**RIGHT OF WAY APPLICATION:**

**RIGHT OF WAY: POL-2025-58  
LAND USE: LUC-2026-57  
17, 19, 21, 23 & 25 MCAULEY ROAD  
PORTOBELLO**

## **APPLICATION POL-2025-58 & LUC-2026-57: 17, 19, 21, 23 & 25 MCAULEY ROAD, PORTOBELLO**

Approved Plan for POL-2025-58 and LUC-2026-57 (scanned image, not to scale)

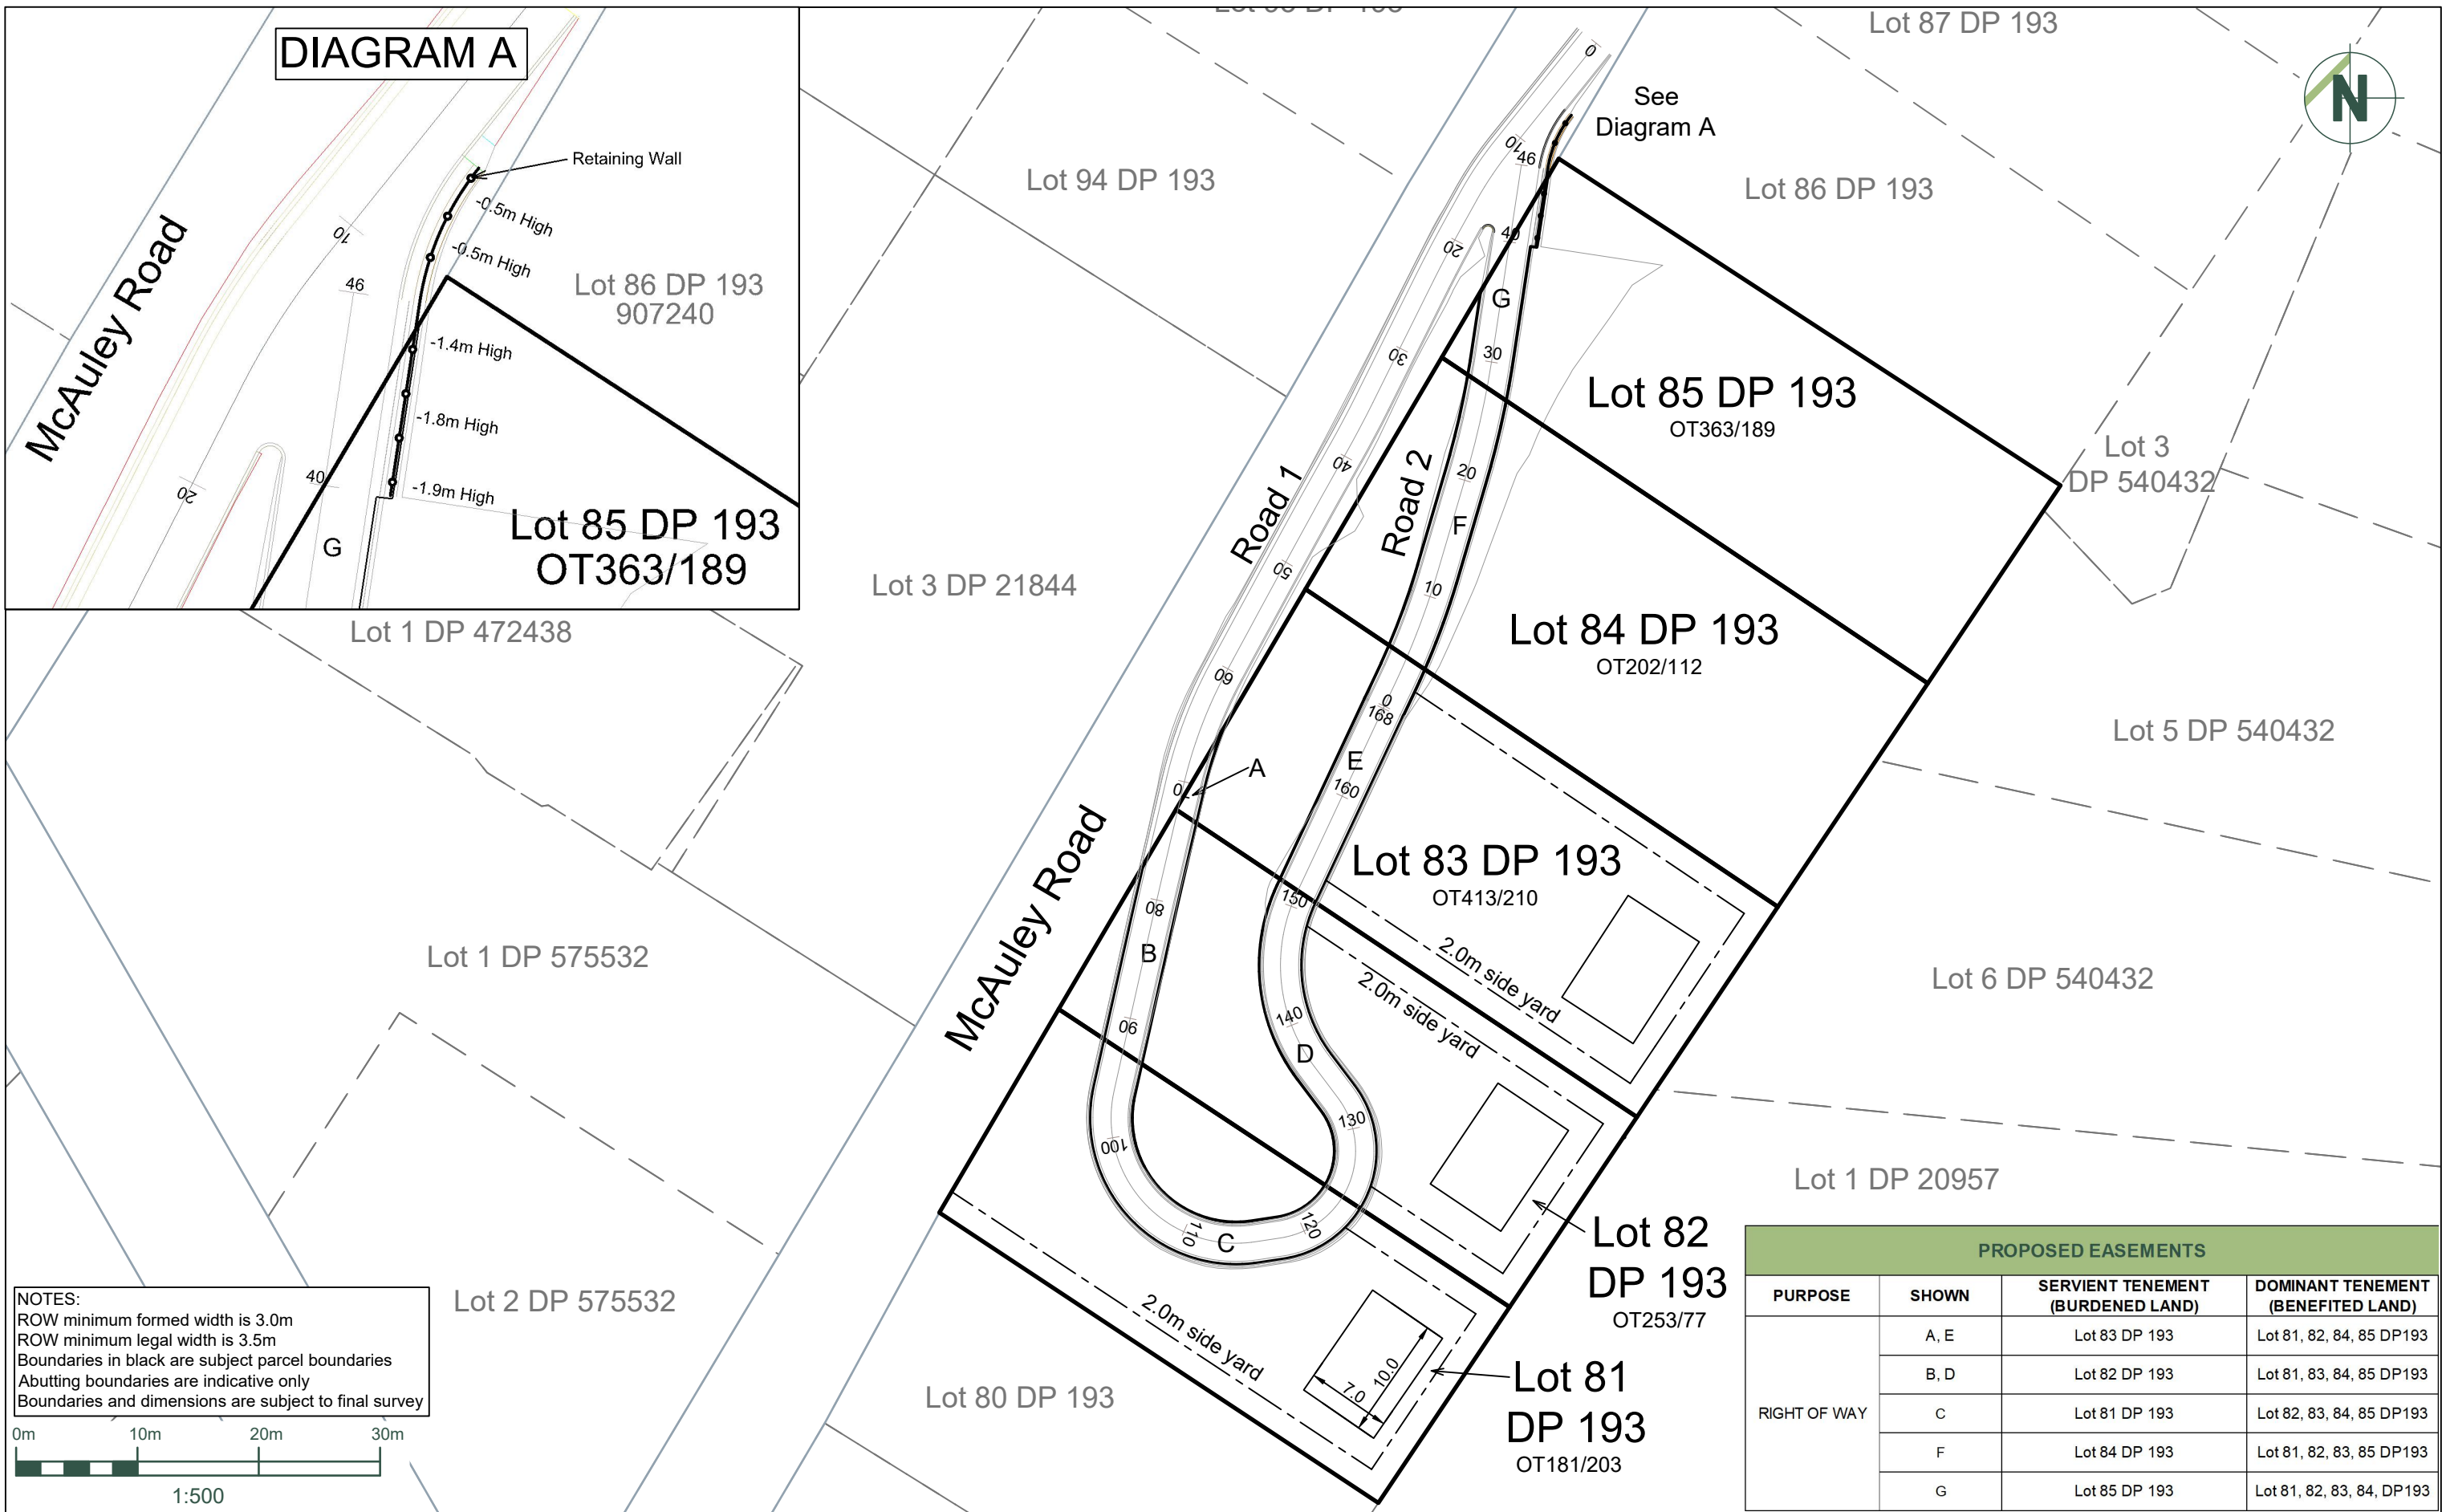
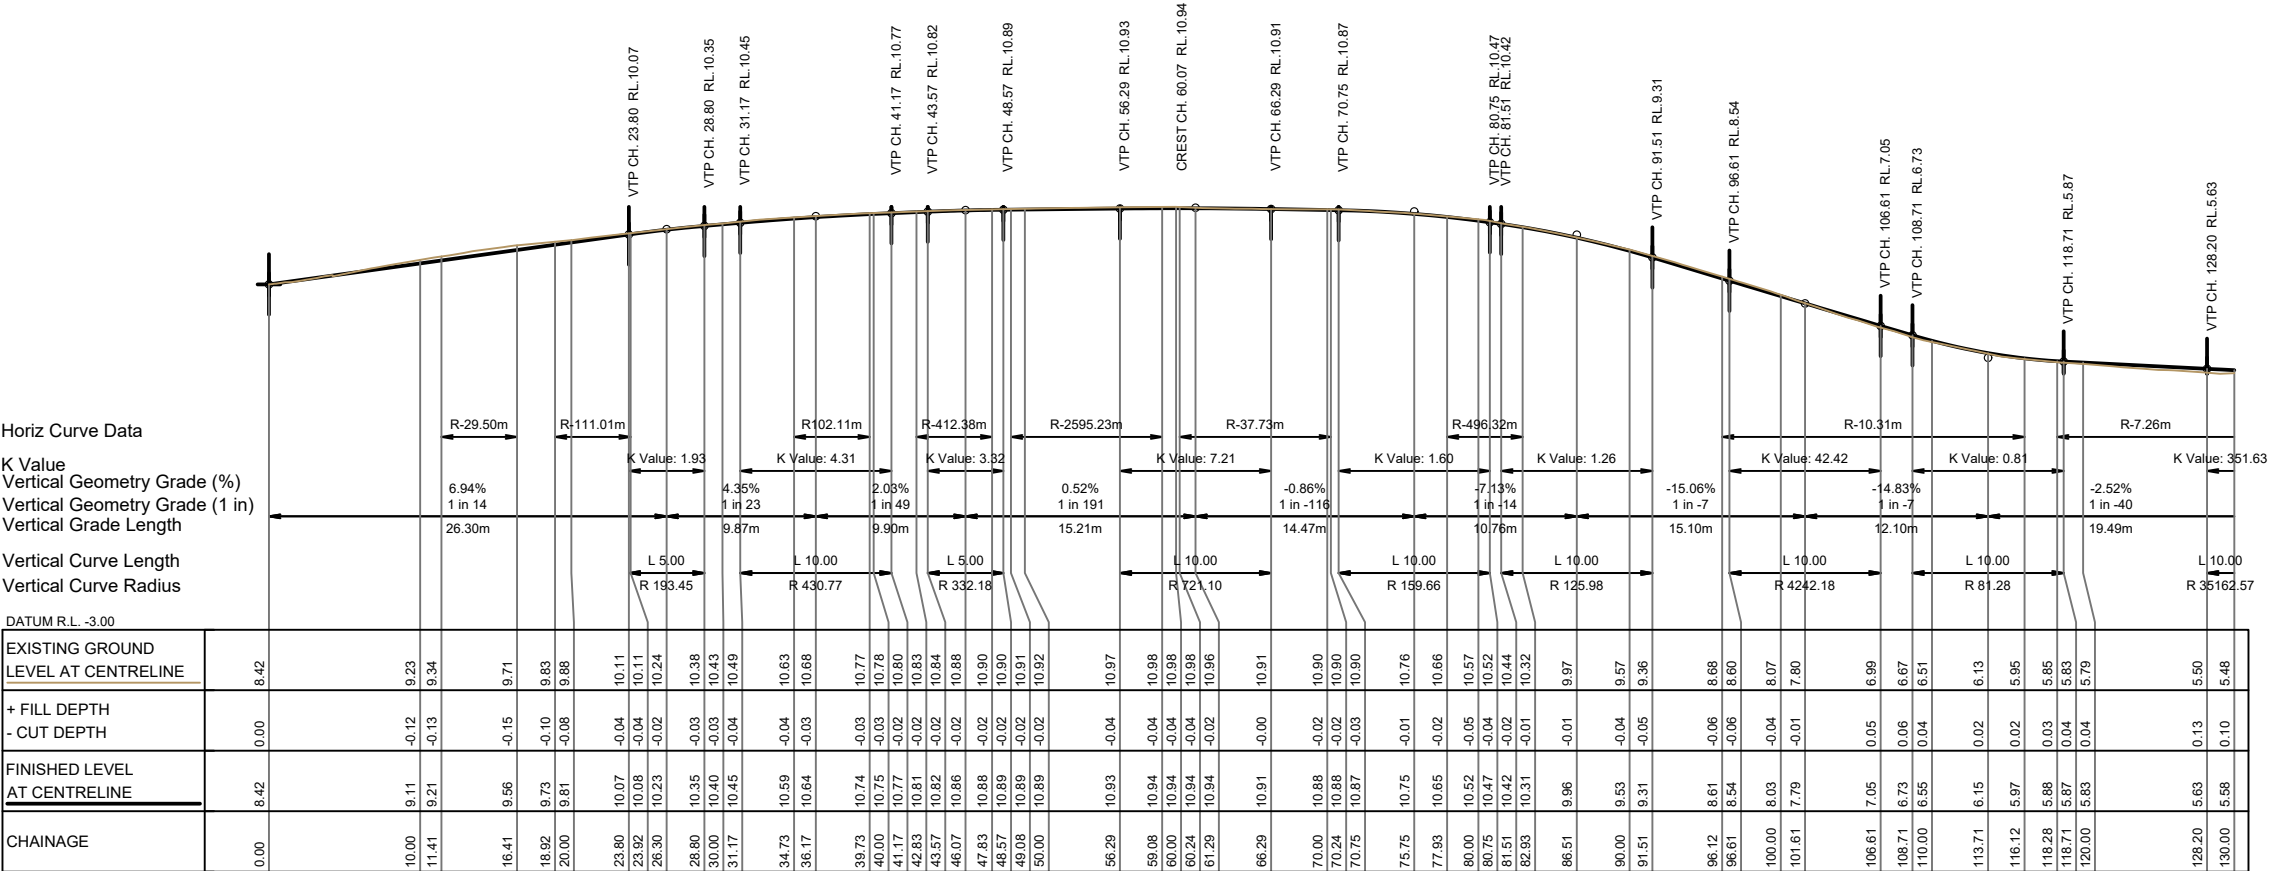
The applicant intends to place fill over the proposed driveway up to a depth of approximately 1.9m in the vicinity of chainage 35.0 on 'Road 2' within 17 McAuley Road. A retaining wall is shown along the driveway's eastern edge between chainages 40.0 to 47.0 or so. This will cross the property boundary shared with McAuley Road.

The maximum change in ground level is expected to be approximately 1.9m. This will raise the driveway within 17 McAuley Road up to meet the existing ground level of McAuley Road, with some of the earthworks occurring within the road reserve itself in order to tie the driveway in with the road formation. As the retaining wall will be supporting fill, there will be no excavations to undermine the boundary or any structure including the existing road. The retaining wall will be required to have building consent prior to works commencing, so there is no expectation that the retaining wall supporting the fill will be inadequate for its purpose.

The retaining wall will cross the road boundary of 17 McAuley Road, therefore contravening setback for a retaining wall supporting fill. Transport has assessed the proposal and has no issue with the proposed retaining wall subject to detailed design being submitted to and approved by Transport prior to works commencing. The proposed earthworks are not expected to have any adverse impact on the stability of McAuley Road in this location as the existing road will not be excavated and the proposed retaining wall will be required to have building consent.

1. *The proposed activity must be undertaken in general accordance with the approved plan and long sections prepared by Patersons Land Professionals, attached to this certificate as Appendix One, and the information provided with the resource consent application LUC-2026-57 received by the Council on 10 December 2025, except where modified by the following:*

Road 1 - Longsection

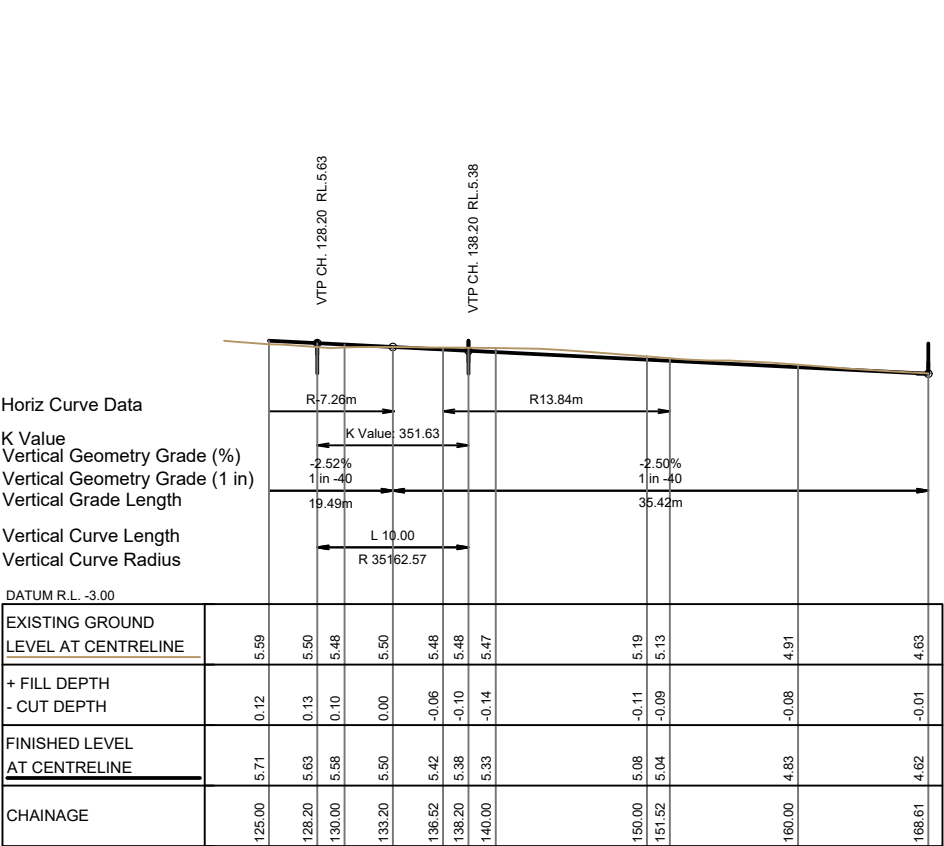
These changes are now limited to lowering a short section of McAuley Road near the northern vehicle crossing as well as increasing the height of the northern vehicle crossing to reduce the gradient of this formation. The first 5.0m of the vehicle crossing will now have a gradient in the order of 1 in 15 or 6.81%, transitioning to a maximum gradient of 1 in 5 or 20.31%. A retaining wall will need to be constructed along the eastern edge of the upgraded formation to achieve this. The wall will vary in height between 0.5m and 1.9m with the retaining wall height of 0.5m being located within Road Reserve. Overall, Transport is generally supportive of these changes to the proposal.

Rule 6.6.3.7.a requires that the maximum change in gradient without transition for driveways is 1 in 8 for summit grade changes or 1 in 6.7 for sag grade changes. In addition, Rule 6.6.3.7.b requires that the gradient of the first 5.0m measured from the road boundary into the site must be no greater than 1 in 8. As per the revised long section provided by the applicant, it is noted that the proposed upgraded vehicle crossings and the shared accessway within Rights of Way A to G will be formed to comply with this requirement and is acceptable.
